STN 50-470F

December 5, 1984
LD-84-071

Subject: High Pressure Safety Injection Flow

FIGURE 1
0.05 FT² BREAK - REDUCED HPSI PUMP DELIVERY
PEAK CLAD TEMPERATURE

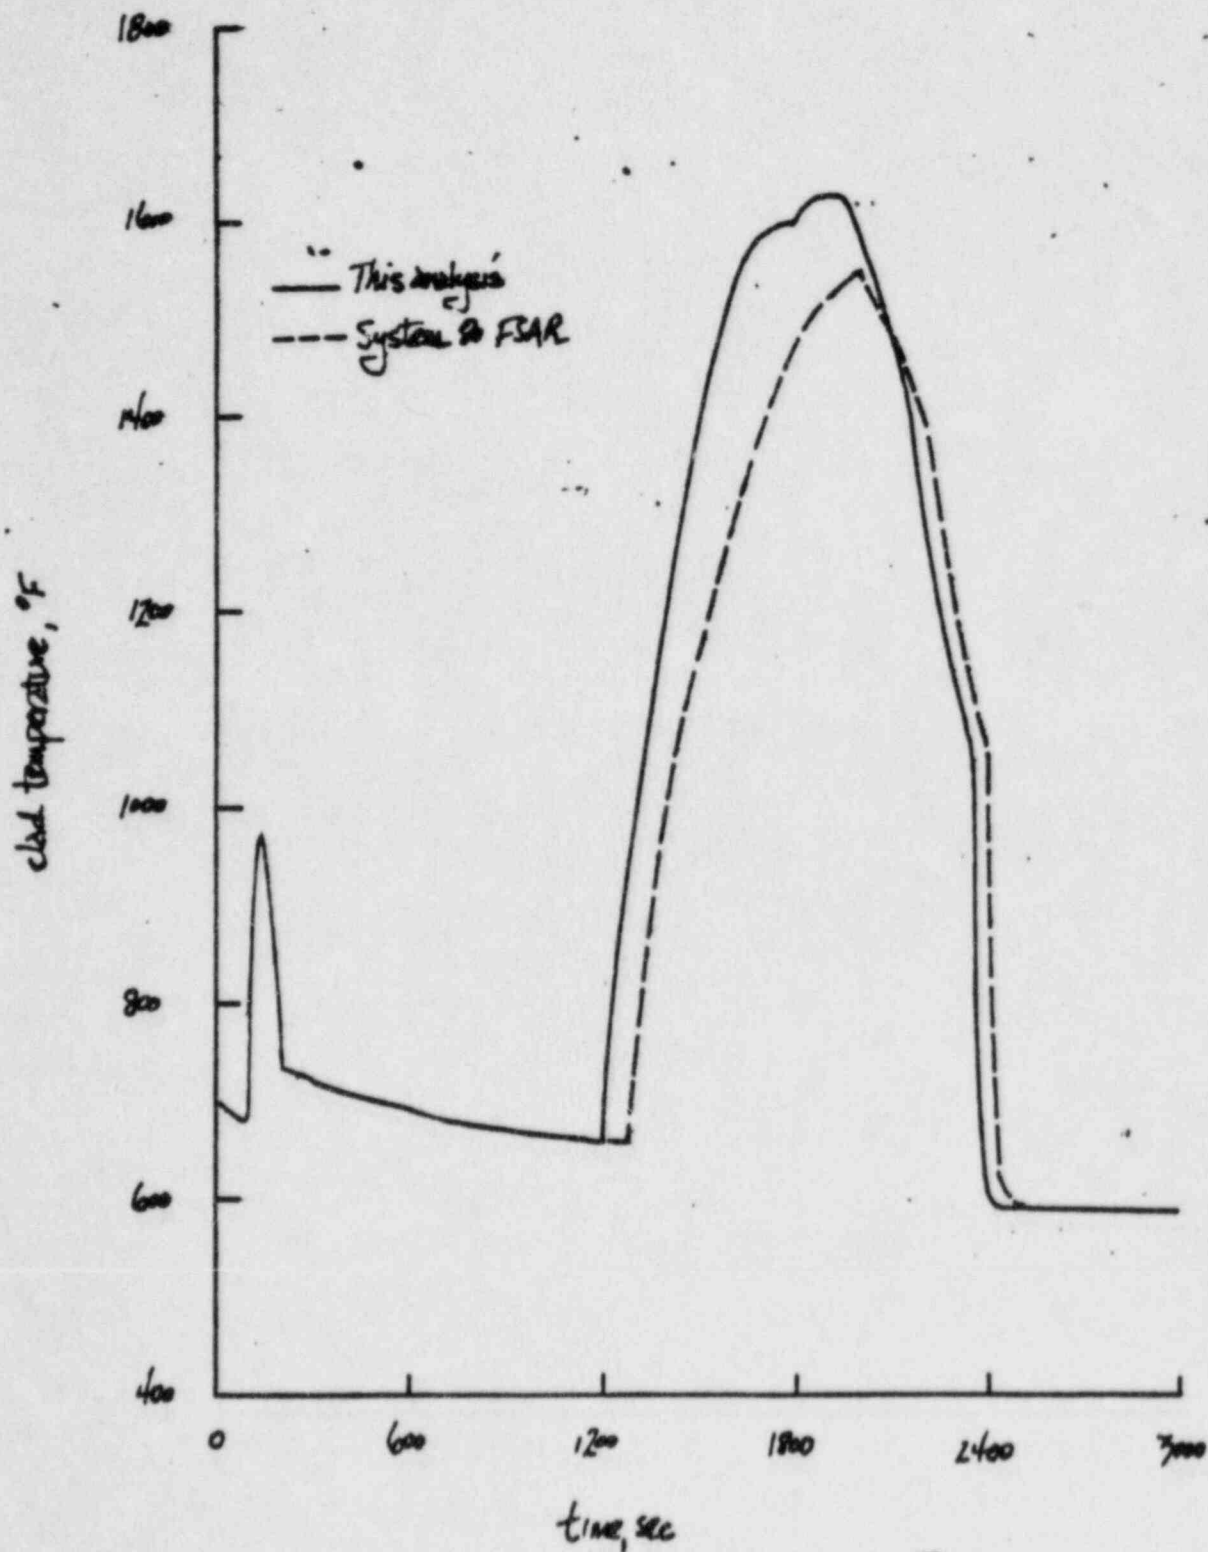
A comparison of the previous peak clad temperature and two-phase mixture height in the core is attached (Figures 1 and 2). Also attached is a CESSAR change that is provided for your review. It will be incorporated into CESSAR in the next amendment.

A review of Figures 1 and 2 indicates that the maximum peak clad temperature for this break size increased from 1557°F (from previous CESSAR analyses) to 1630°F. This increase is attributed to the slightly longer period of core uncover resulting from the decrease in HPSI flow delivered. This small break analysis is still conservatively bounded by the most limiting large break LOCA peak clad temperature (2169°F occurs in a 1.0 ft² double-ended cold leg guillotine break).
